## Project Placed in an Inactive Status FY03

1. Project Name: Pago - Nuuuli Shore Protection Project
2. Date of Inspection: March 15, 2005
3. Inspection Personnel:

4. The purpose of this inspection was to verify that no actions have been taken to correct the deficiencies identified in the CEI report dtd April 3, 2003. Photographs taken were overall in nature and do not reflect all deficiencies.

**CONTINUING ELIGIBILITY INSPECTION (CEI) REPORT**  
**FOR HURRICANE & SHORE PROTECTION PROJECTS**  
Honolulu Engineer District  
CEPOH-EC-T

- a. Sta. 2+00, Unauthorized drainline installed thru the revetment, armor stone not keyed or fitted.

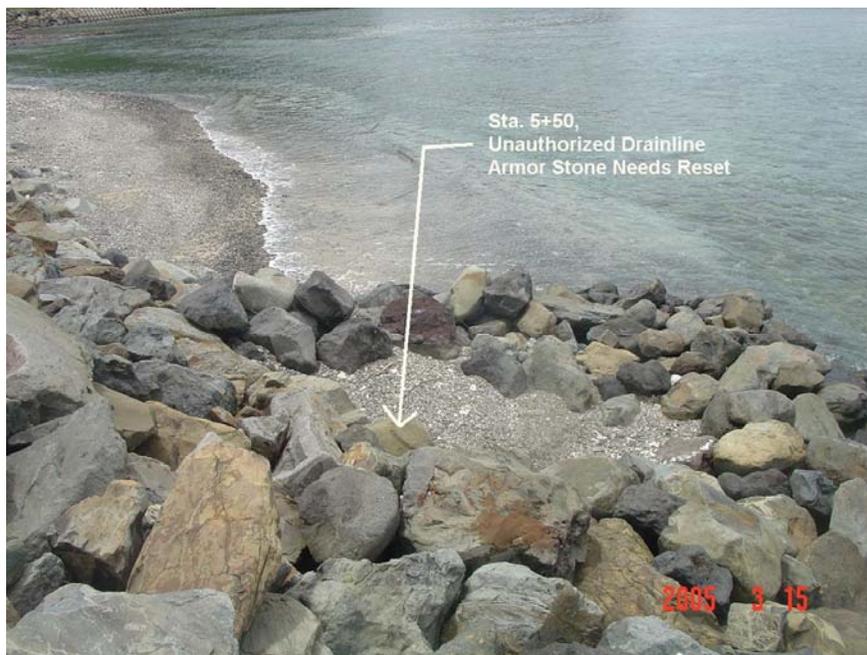
Approx Sta. 2+00  
Unauthorized Drainline Installed Armor Stone Not Set
